ATTACHMENT 2 to AEP:NRC:1169

PROPOSED REVISED TECHNICAL SPECIFICATIONS PAGES

CURRENT PAGES MARKED-UP TO REFLECT PROPOSED CHANGES

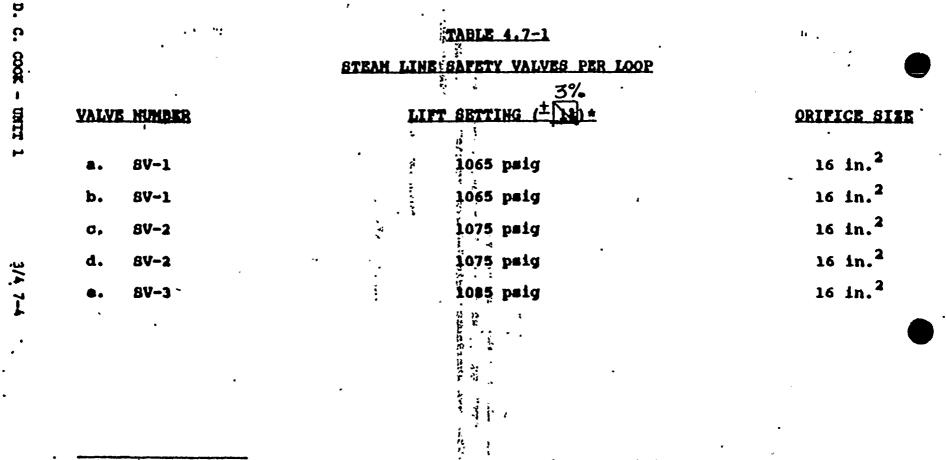
The safety value is OPERABLE with a lift setting of $\pm 3\%$ about the nominal value. However, the safety value shall be reset to the nominal value $\pm 1\%$ whenever found outside the $\pm 1\%$ tolerance.
